NORTH FALLS

Flood Risk Assessment (Clarification regarding flood risk associated with watercourse crossings) - Technical Note

Document Reference: 9.46
Volume: 9
Date: April 2025
Revision: 0

Figure 1-1: Site location of WX-22A and WX-23 along the cable route

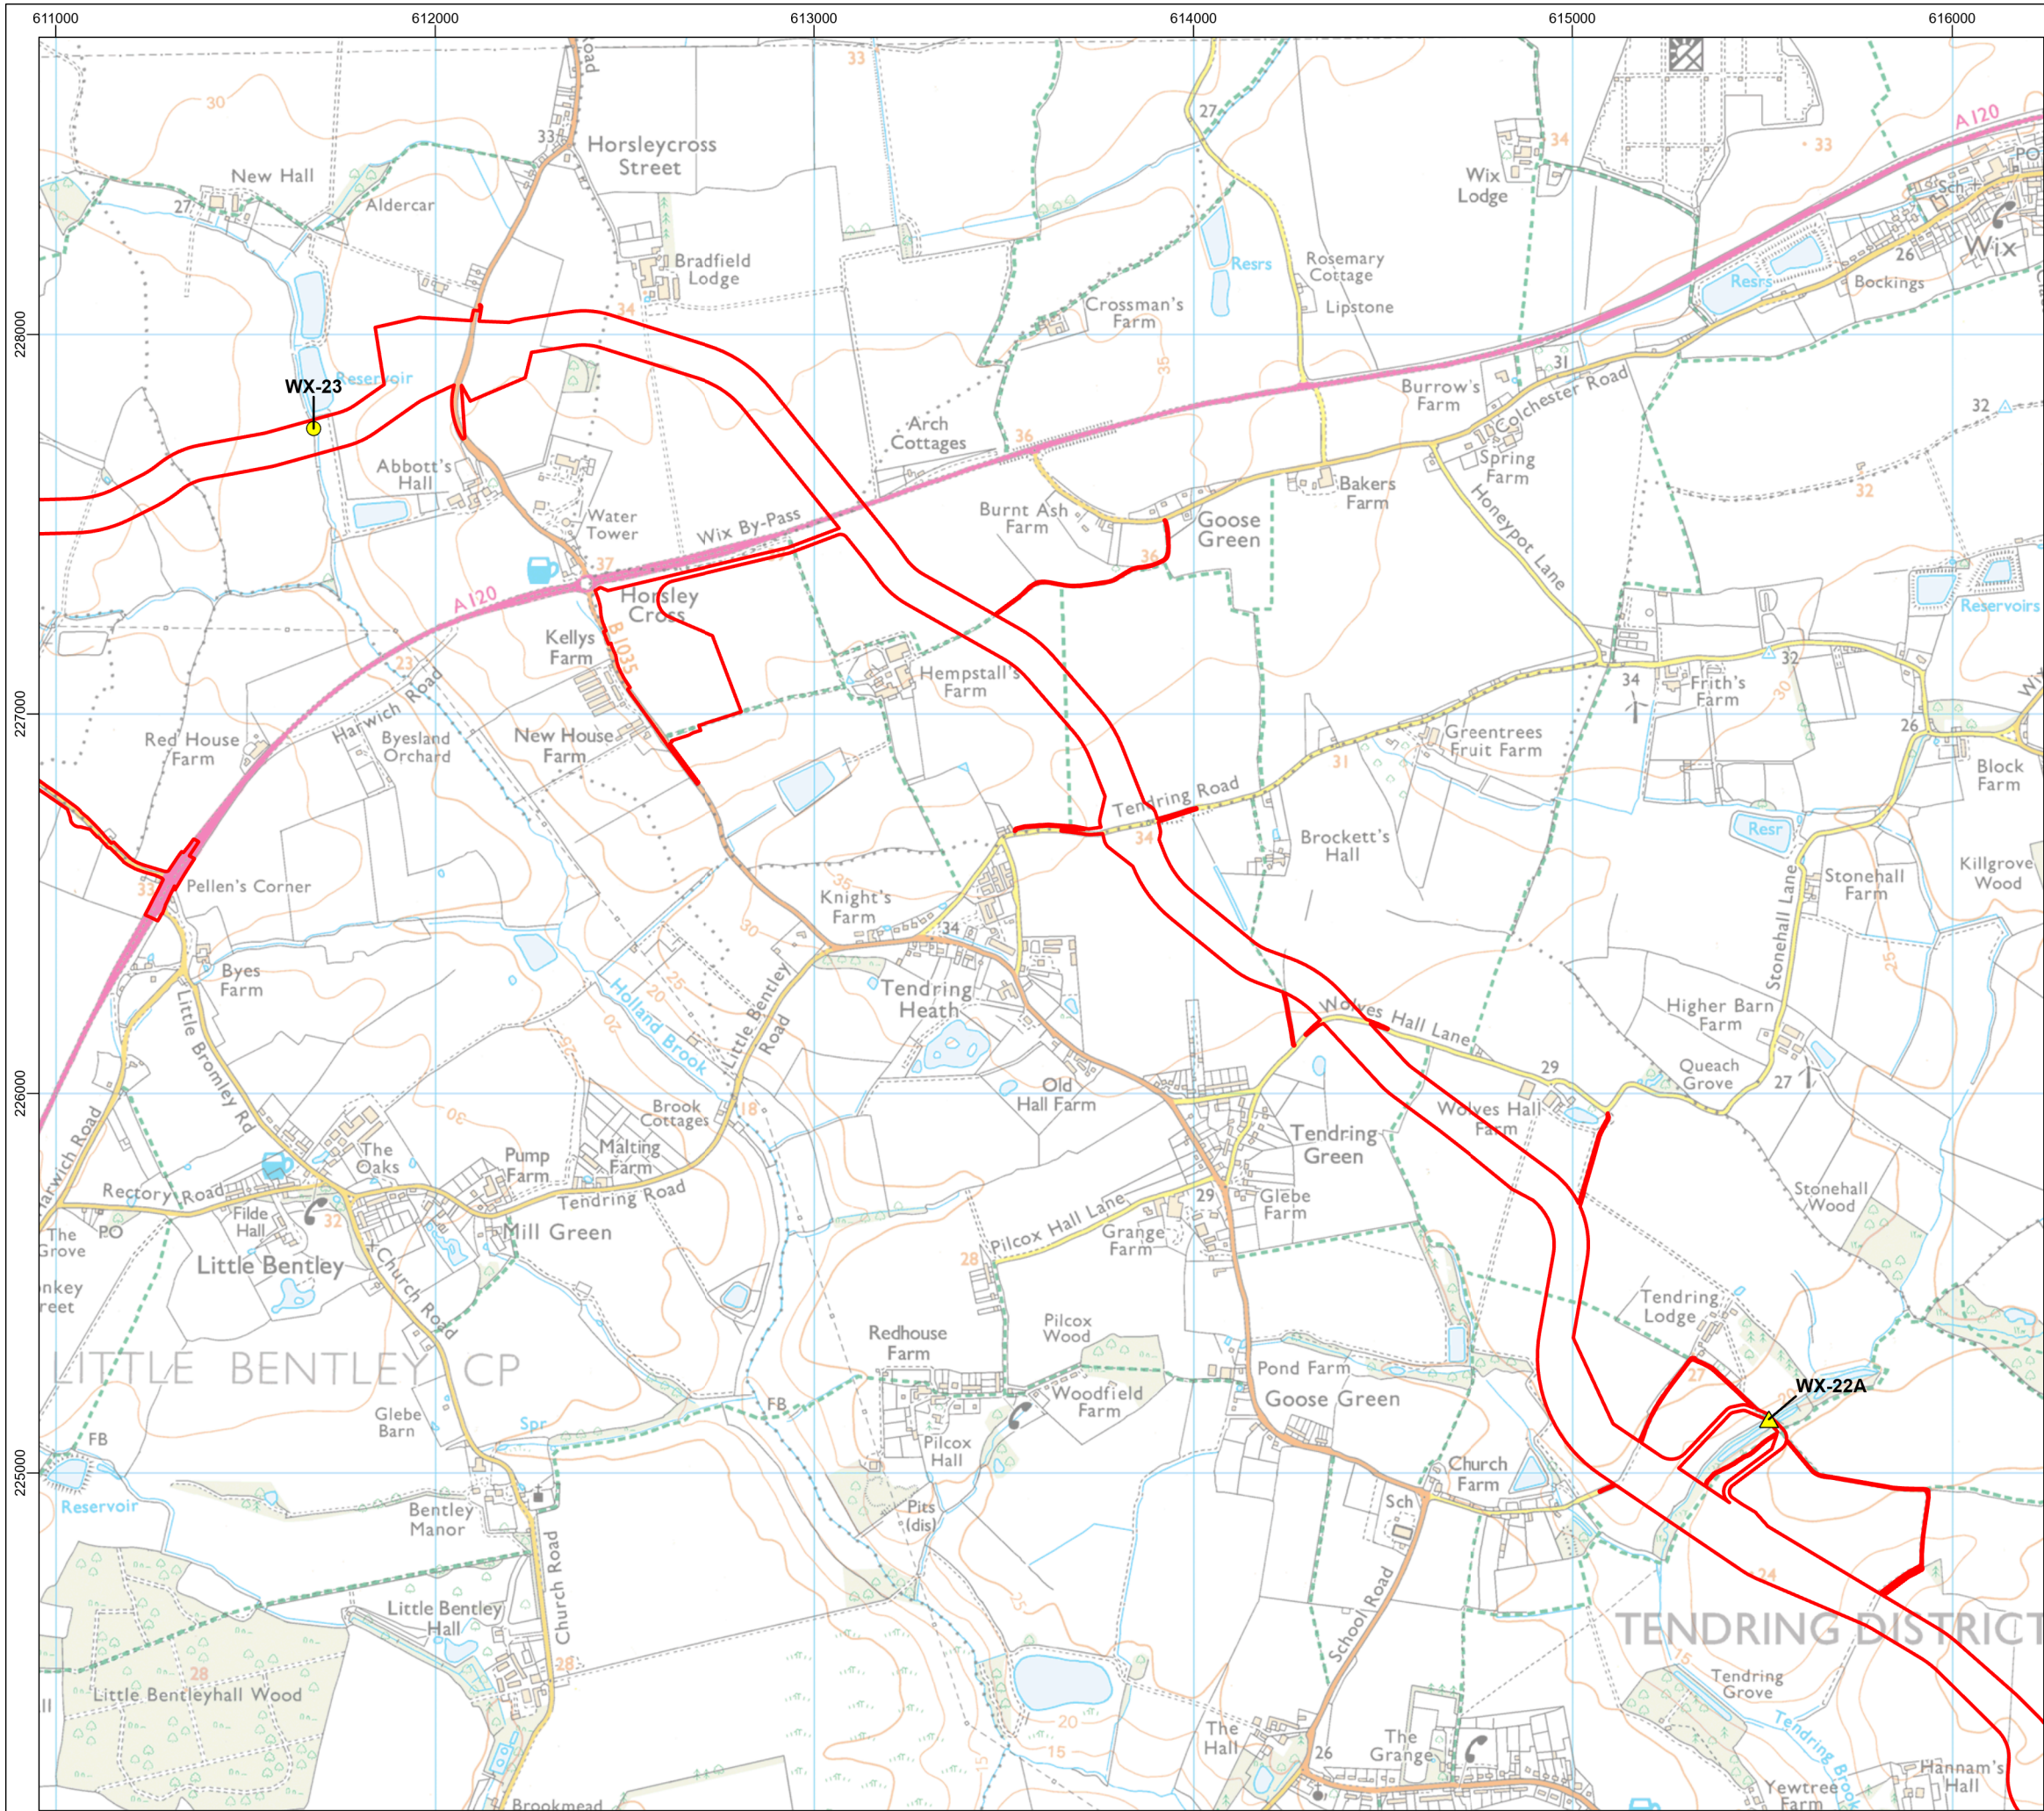
3. The Environment Agency in their Relevant Representation **[RR-091]** expressed concerns regarding the potential for there to be an increase in flood risk to third parties as a result of the implementation of watercourse crossings located within Flood Zones 2 and 3.

However, at paragraphs 111 and 113 the Applicant confirms that haul road crossing and its associated flood risk will not be considered until the detailed design stage post consent. Similarly, at paragraphs 382 and 383 the Applicant advises that the flood risk for the remaining trenched crossings will be assessed post consent. As well as its responsibilities for Main Rivers the Environment Agency does have an interest in ordinary watercourses where there is associated fluvial Flood Zones 2 and 3a. We do not agree with the Applicant’s approach. Trenched crossings and haul road crossings due to the potential to interfere with the flow of flood water can increase the risk of flooding to third parties.

10. In this Technical Note, the Applicant has sought to respond to the points raised above, providing clarification with regards to flood risk at the potential haul road crossings and demonstrate that, should the crossings be required, they will not increase flood risk to off-site receptors.

Figure 6-3: LiDAR DTM with Contour Lines and Flood Map for WX-22A

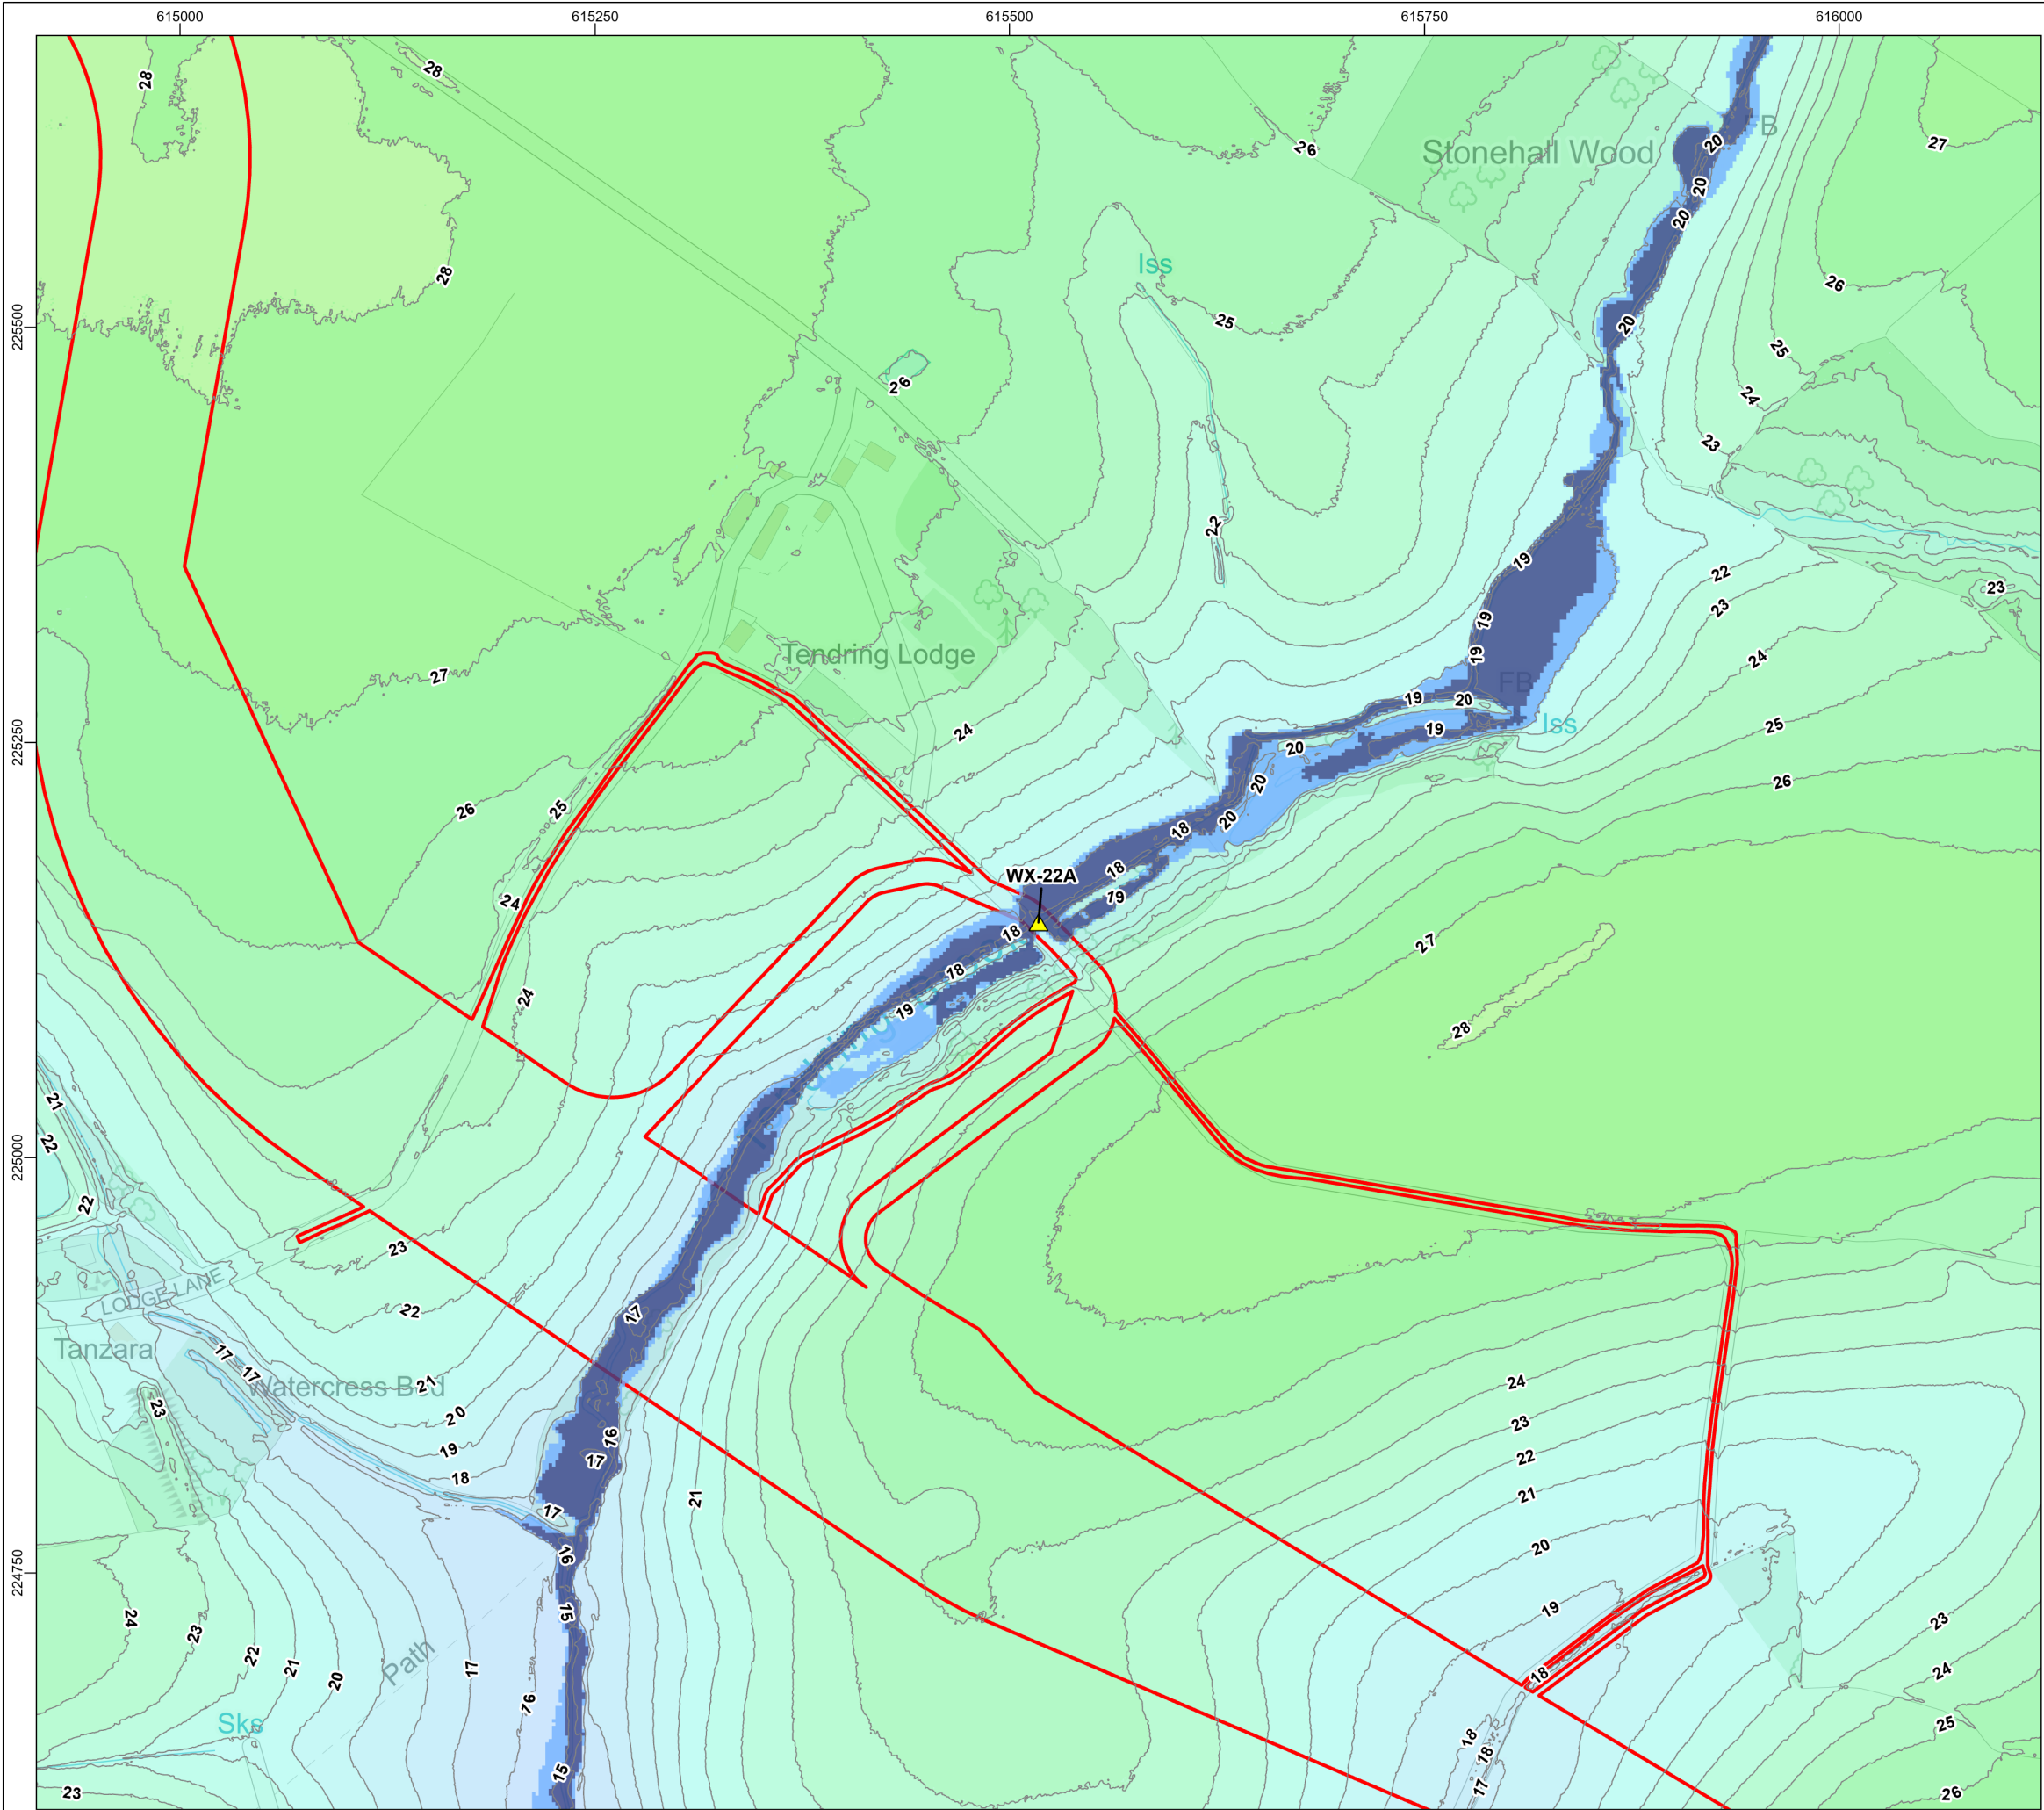
38. At WX-22A the channel of the Tendring Brook is considered to have an elevation of approximately 18 metres above ordnance datum (mAOD).
39. The left bank (southern side) has elevations of 19mAOD, which increases to 23mAOD as the bank increases in height rapidly.

42. In order for the agricultural fields located beyond the left bank to experience fluvial flooding, the watercourse would need to exceed its banks by a depth of approximately 5 metres above the main channel.
